# A428 Black Cat to Caxton Gibbet improvements

9.55 Applicant's response to Cambridgeshire County Council's  
comments on archaeological mitigation areas

**9.55 Applicant's response to Cambridgeshire County Council's  
comments on archaeological mitigation areas**

<b>Regulation Reference:</b>	Rule 8(1)(k)
<b>Planning Inspectorate Scheme Reference</b>	TR010044
<b>Application Document Reference</b>	TR010044/EXAM/9.55
<b>Author</b>	A428 Black Cat to Caxton Gibbet Improvements Project Team, National Highways

<p>Plate 1 Proposed CCC Area Site 10</p>	 <p>Plate 2 AMS Area Site 10</p>

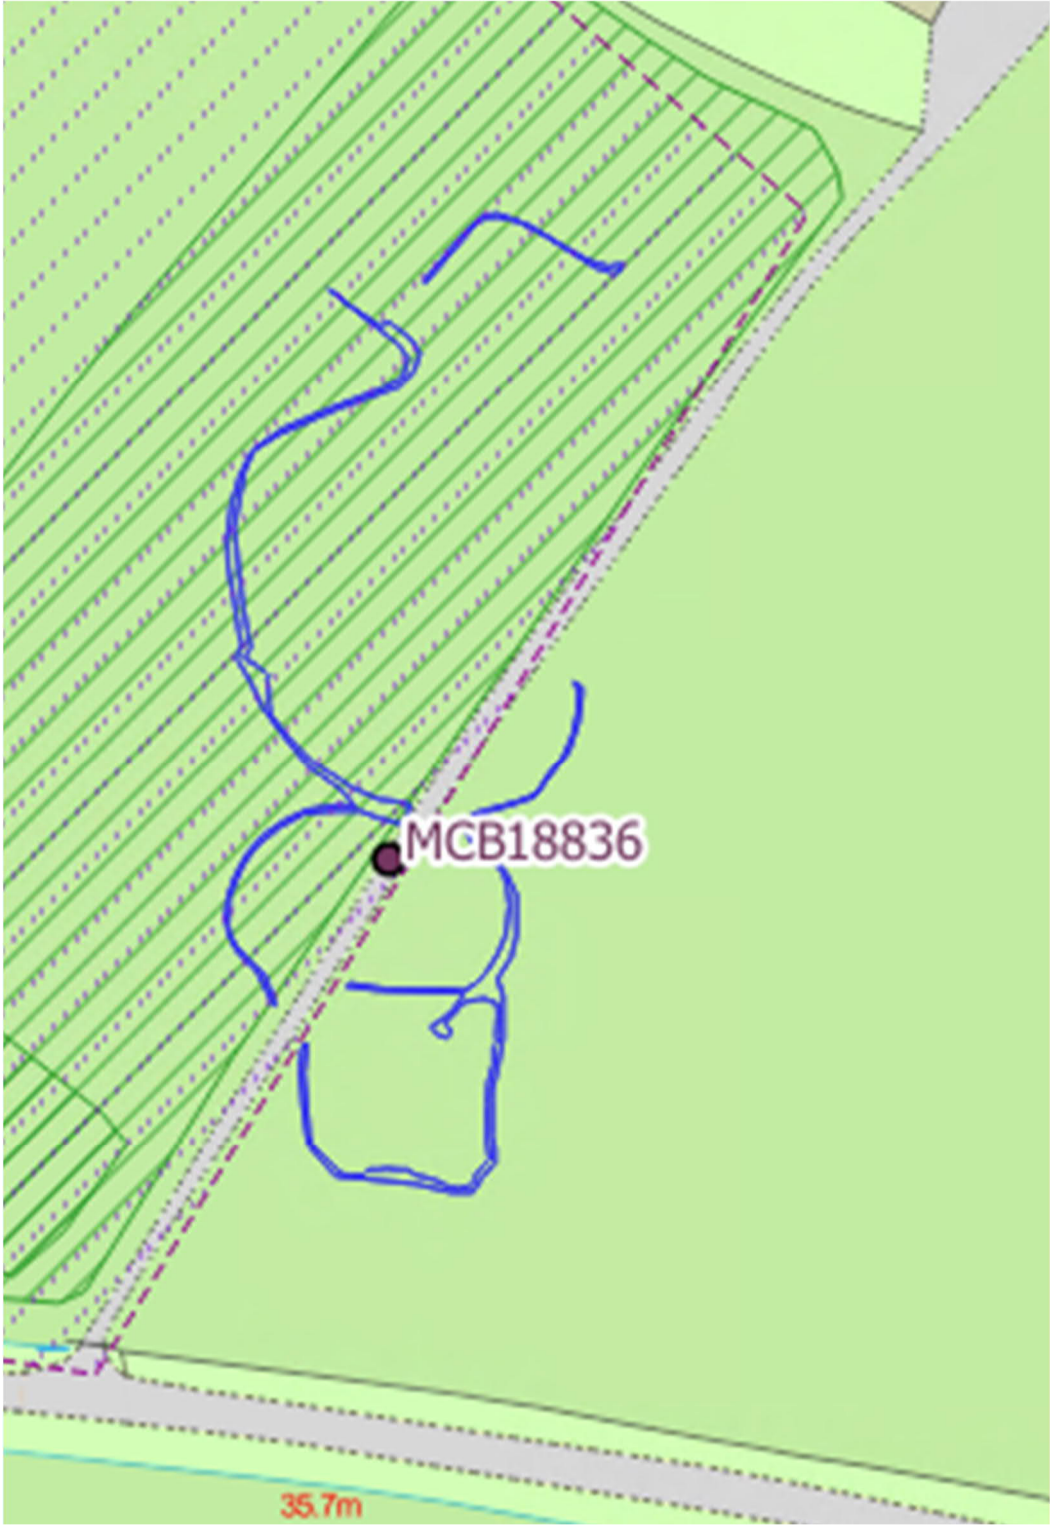
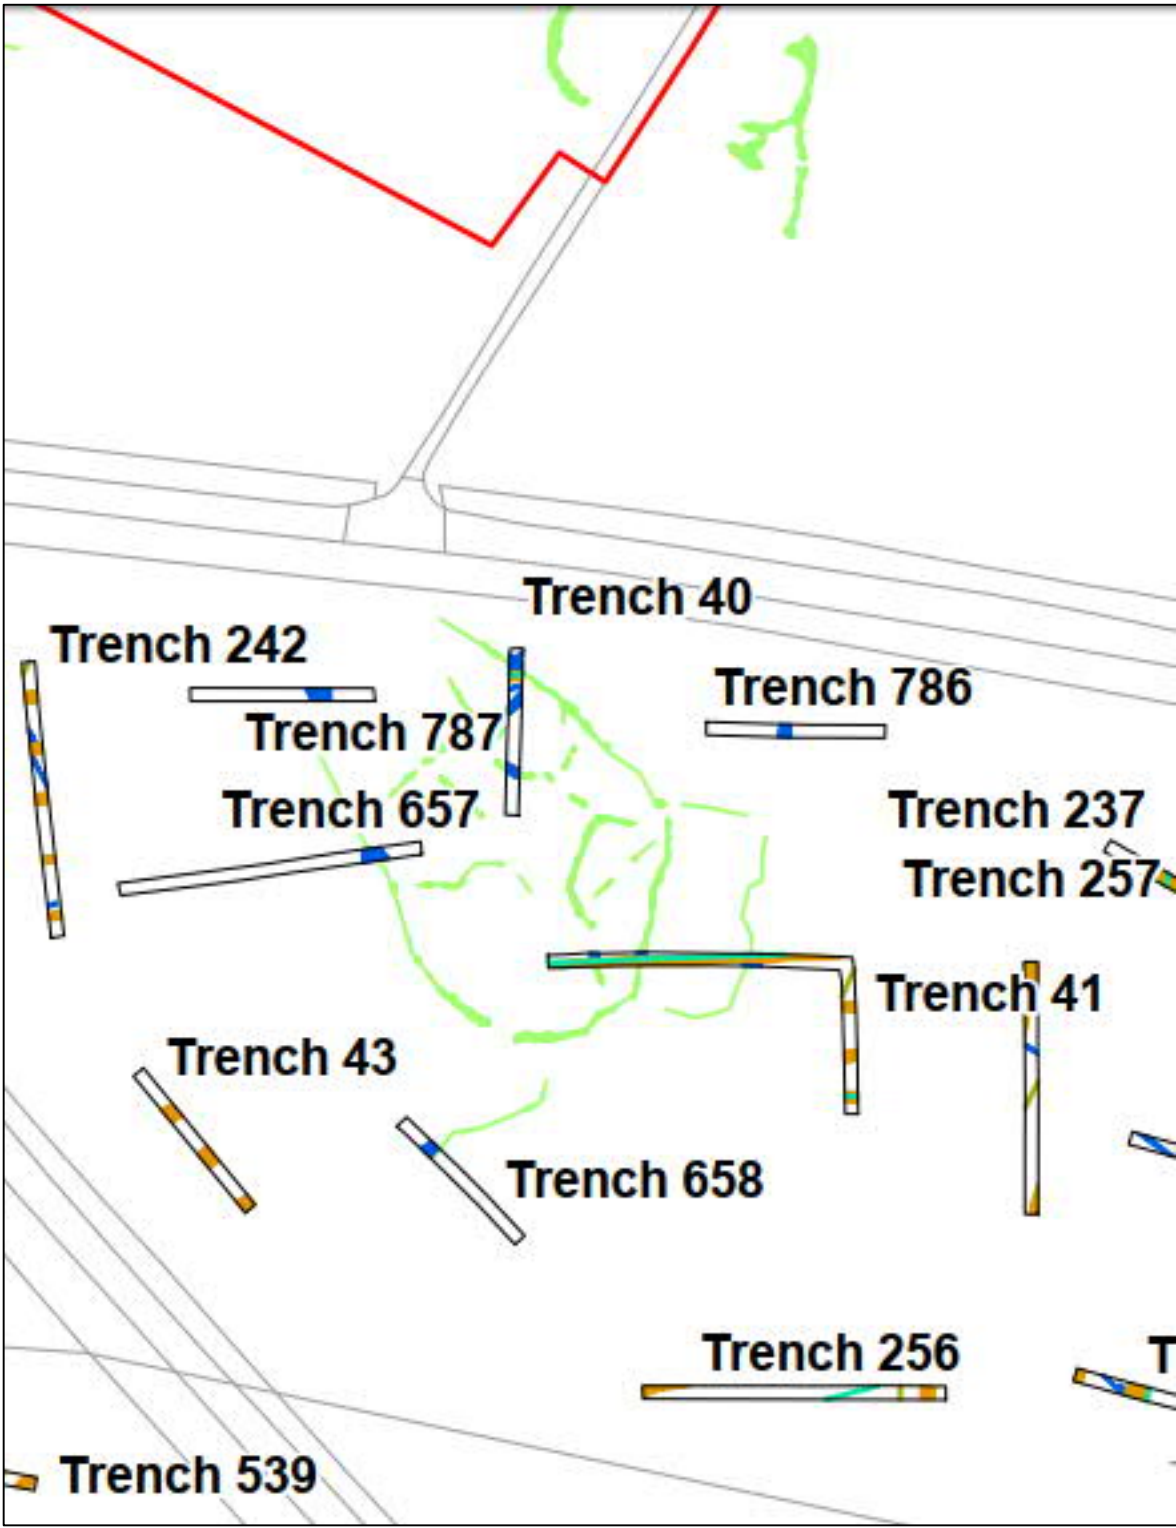
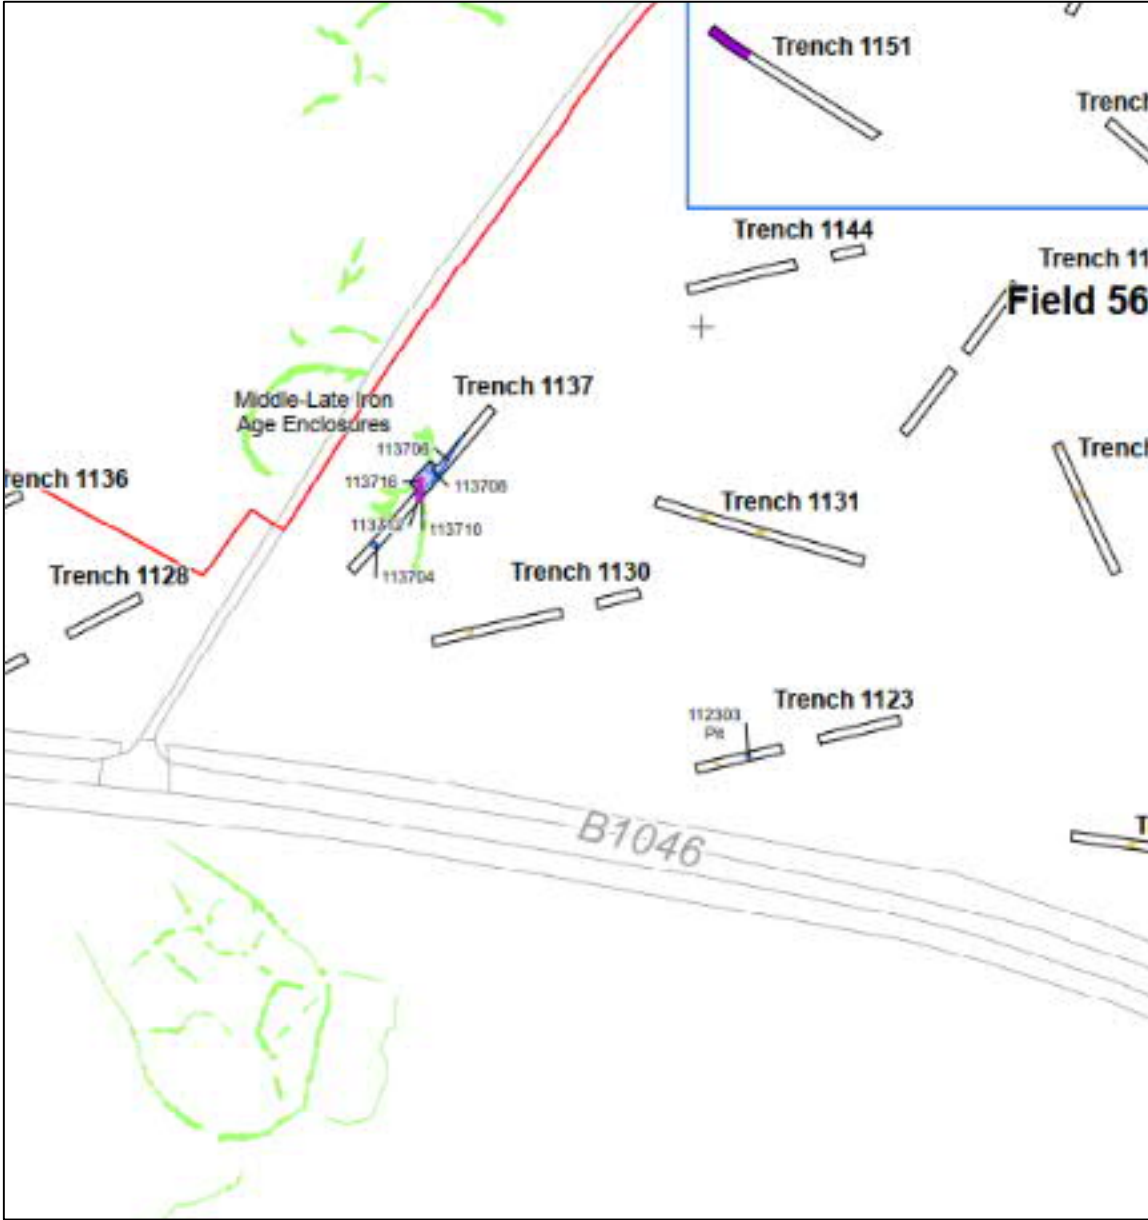
Site Number and Field Number	CCC Position	Applicant Position
Site 10, Field 53	<p>The categorisation of the site is agreed but the area for examination is not. The excavation area needs to extend south-westwards towards the brook where deep colluvial soils infilled the small valley through which the brook courses. Examination of the old land surface (late prehistoric/Roman) will be possible once the colluvium has been stripped. If palaeochannels are present, appropriate palaeoenvironmental sampling and excavation will be required to address research objectives in 4.4.11 c-g</p>	<p>The extension of the excavation area southwards is not warranted and consequently no archaeological work is proposed here. Colluvial deposits will be examined (as discussed below) but the trenches undertaken during the evaluation phases in this location were largely devoid of archaeological features. Trenches 538, 284, 650 and 537 were located in the area proposed by CCC (NB the trench array which CCC have used in their image were subsequently amended during site works with their agreement). Of these, Trench 538 contained a palaeochannel (proposed for examination), Trench 284 was devoid of archaeological features, Trench 650 contained only a medieval or post-medieval furrow and Trench 537 contained an undated pit which extended outside of the trench and into the area covered by the mitigation area. Features in Trenches 284 and 650 do not merit further investigation.</p> <p>The colluvial deposits will be examined. The AMS states that the following is required: "Sampling of colluvium and palaeochannel along beck". As the extent of the colluvium would be defined by initial analysis, the Applicant did not want to be prescriptive about the size of the area to be investigated along the stream. The requirements for dealing with colluvium and palaeochannels are detailed in Section 10 of the AMS. Paragraph 10.2.10 states "Where warranted, areas identified for geoarchaeological assessment may be stripped to reveal archaeological features sealed by the colluvium. The requirement will be dependent upon the results of the boreholes." The strategy allows for sampling of both the colluvium deposits and the potential palaeochannel. The total extent of these deposits is unknown and will be identified within the area to be impacted by the Scheme. The exact methodology for the soil storage proposed across part of this area will be required before the impact on any colluvial deposits can be confirmed – if no soil stripping is required for construction, for example, there will be no impact.</p>

Site Number and Field Number	CCC Position	Applicant Position
	 <p>Plate 4 Proposed CCC Area Site 11</p>	 <p>Plate 5 AMS Site 11</p>

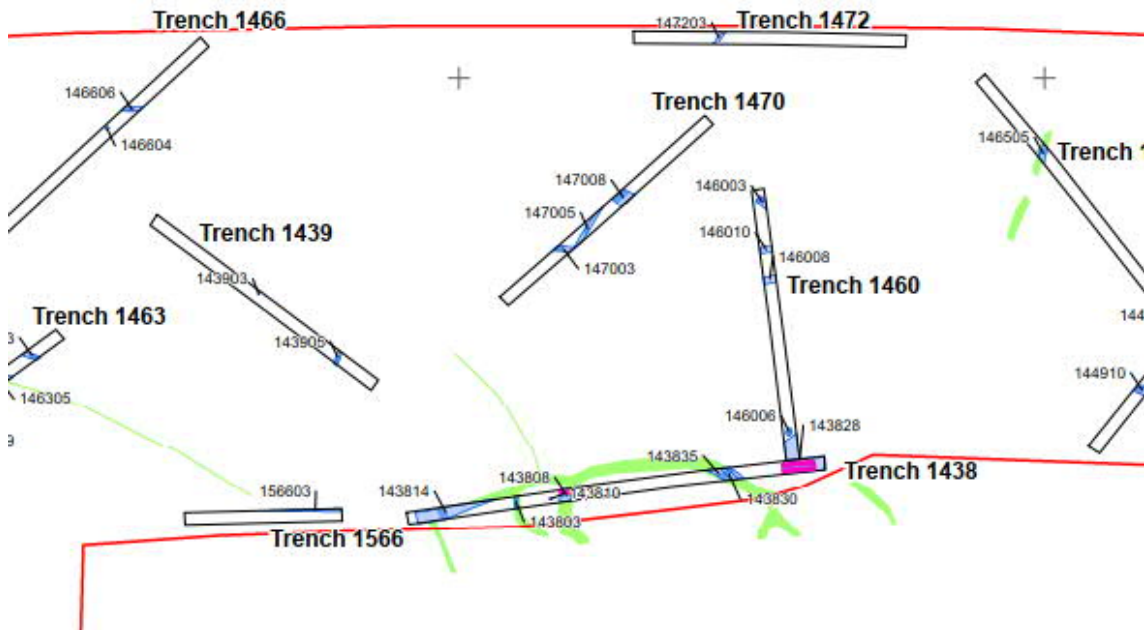
Site Number and Field Number	CCC Position	Applicant Position
		<p>3</p>  <p>Trenching results at Site 10</p> <p>Plate</p>
Site 11, Fields 54 & 56	<p>Categorisation is agreed but the excavation box in Appendix D requires enlarging as it is too tight to the geophysical anomalies of enclosures tested by evaluation, allowing little buffer to test evidence beyond the enclosures. As there is a chain of enclosures heading northwards out of the Order Limits (National Mapping Programme transcriptions of aerial photographic evidence on the Bedfordshire and Cambridgeshire Historic Environment Records attest – see also 6.3 ES Volume Appendix 6.4 <i>Geophysical Survey Phase 1&amp;2 Part 2</i> Figure C-10) we are able to see the broader landscape area occupied by Iron Age remains and this is true in Field 54 where they are known to extend west and south of the proposed excavation area (to Site 10 Field 53. The act of enclosure is a research objective proposed in this AMS and the move from unenclosed settlement in the earlier Iron Age to enclosed form in the middle of the period (4.4.8, 4.4.11a). The excavation area should be widened on its western and southern sides.</p>	<p>Following consultation with CCC on 15 and 29 October 2020 this area was extended and amalgamated. However, the extent of the area proposed by CCC was not agreed. In Field 54, Trenches 43, 256 and 787 on the western and southern side of the area were either blank or contained only furrows. To the east, the north-south arm of Trench 41 contained only furrows, and Trench 257 further east contained an undated ditch, which did not warrant inclusion in the mitigation area for this Iron Age site.</p> <p>In Field 56, at the northern end of the area proposed by CCC, Trench 1144 was blank and Trench 1151 contained only a modern material from demolition of a barn. While cropmark evidence is apparent in this area, based on this, the geophysical results and the trenching results, features identified as cropmarks are located within the mitigation area. The area was extended to address the initial concerns and to cover the site as one, rather than split into two.</p>

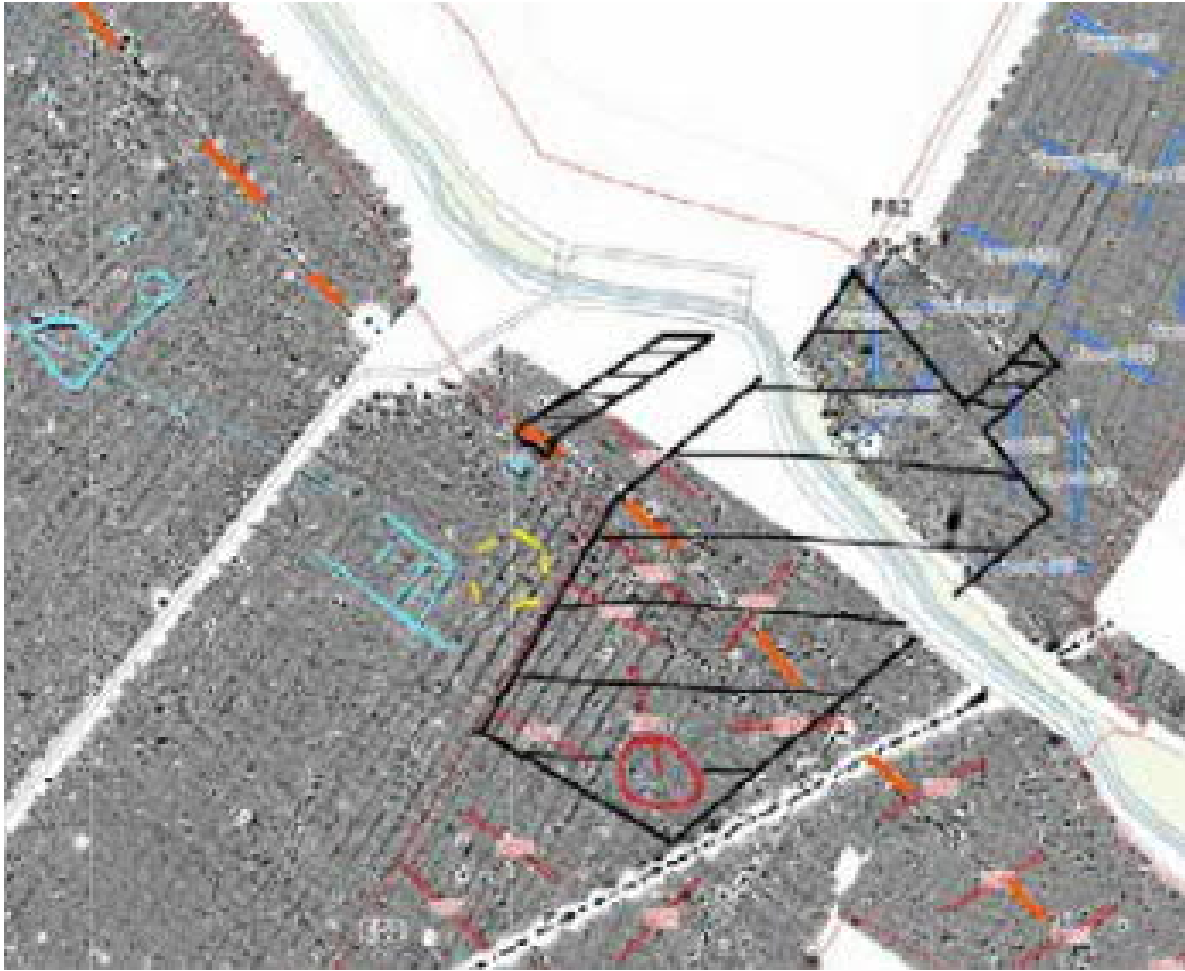
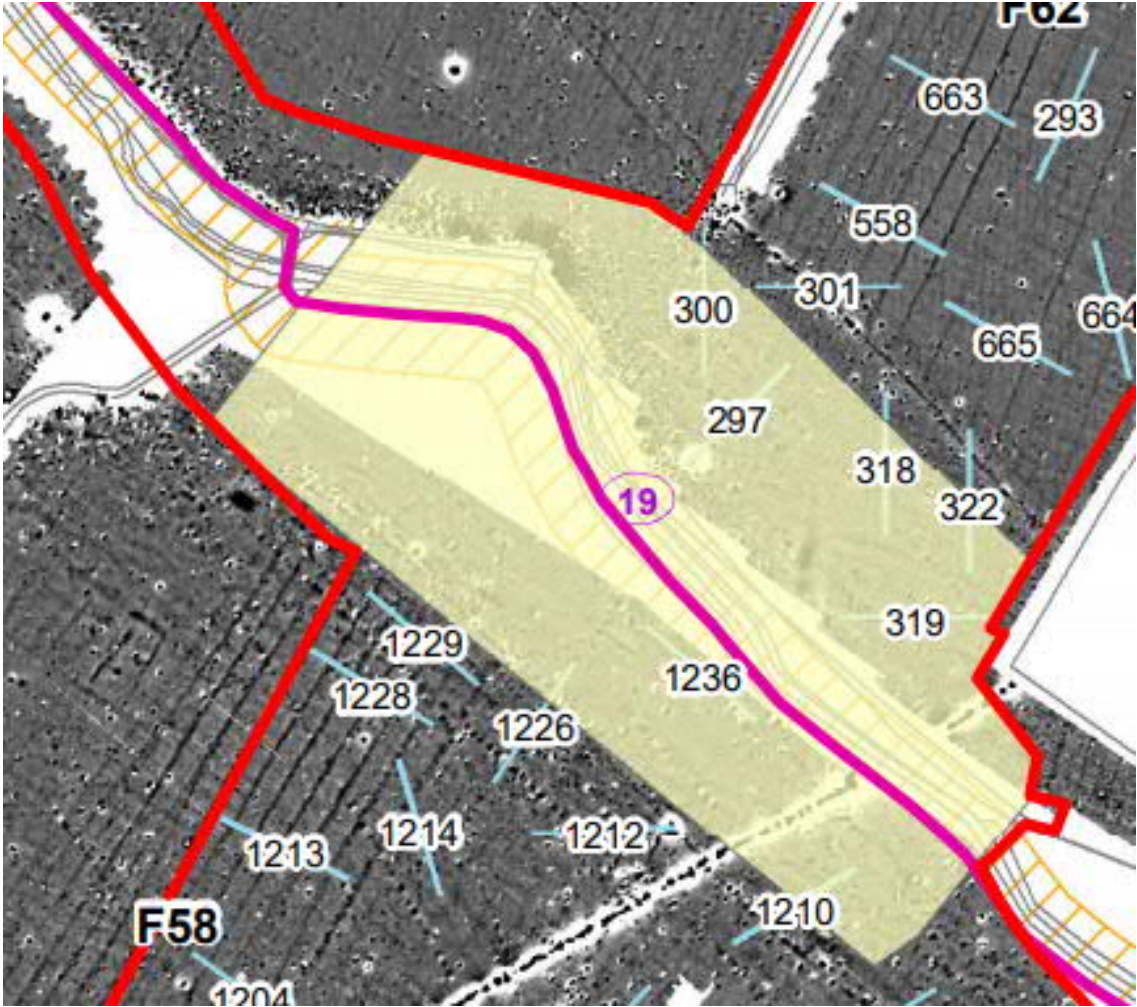
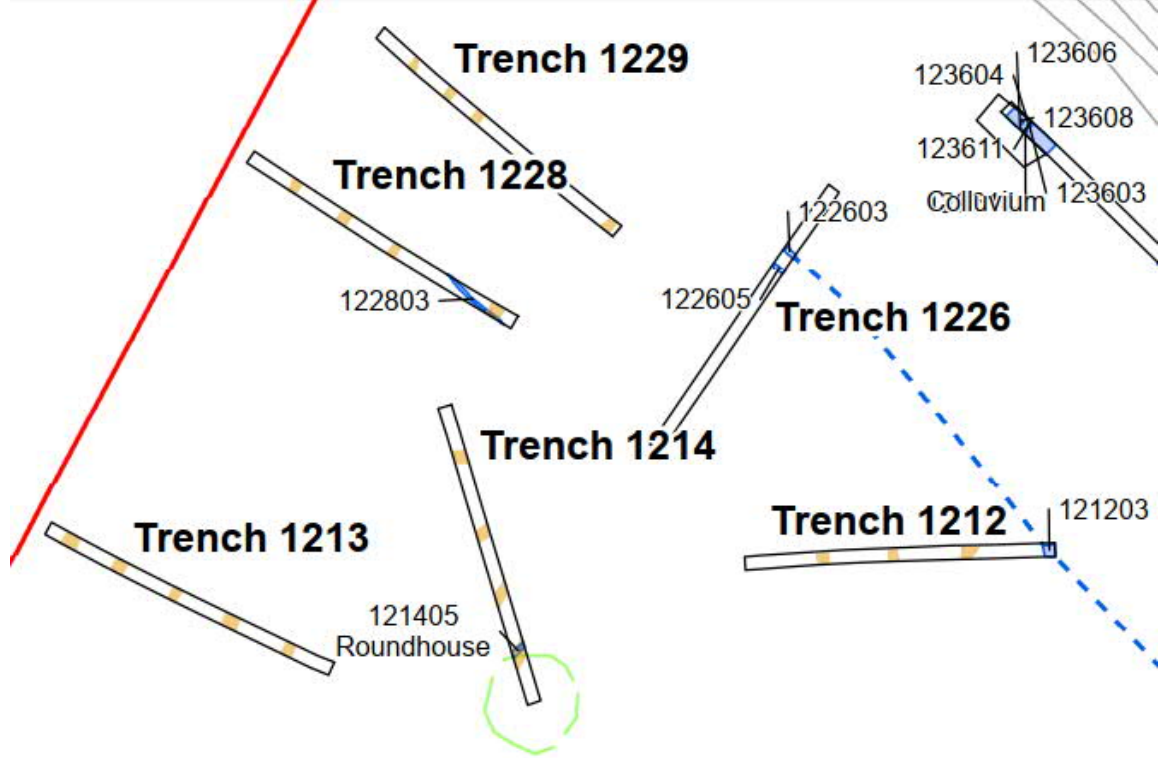
Site Number and Field Number	CCC Position	Applicant Position
		 <p data-bbox="1852 1524 2430 1556">Plate 8 Trenching Results at Site 11 in Field 56</p>
Site 18, Fields 73 & 74	<p data-bbox="394 1591 1549 1686">This is a major, productive long-lived Iron Age and Roman site but has an over-simplified description in this AMS. It should be subject to detailed excavation as a site of intrinsic qualities if the research objectives in 4.5 are to be realised.</p> <p data-bbox="394 1703 1549 1848">As discussed with the A428 archaeology team, while the area in Field 73 is approved, we do not agree with the area demarcated for excavation and consider that the Iron Age remains known within the Order Limits in the eastern part of the Field 74, which are associated with a large settlement (MCB19040) to the south of the Order Limits, are also excavated – to determine the relationship and evolution of the Iron Age and Roman settlements and fulfil the research objectives set out in 4.5 and</p>	<p data-bbox="1561 1591 2718 1686">Further detail on this site is available in the Applicant's comments on the Written Representation [REP3-008] from Cambridgeshire County Council/ Huntingdonshire District Council/ South Cambridgeshire District Council [REP1-046cf].</p> <p data-bbox="1561 1703 2718 1848">The change in category to this mitigation area has not been raised by CCC previously. Although the site contains extensive archaeological remains forming Iron Age and Romano-British enclosures, these are not of a level to warrant being considered to be of intrinsic value (i.e. they are not so important as to need to be excavated extensively and with increased sampling) but rather is a key site (a site that requires full excavation where investigation is key to understanding a period or site</p>
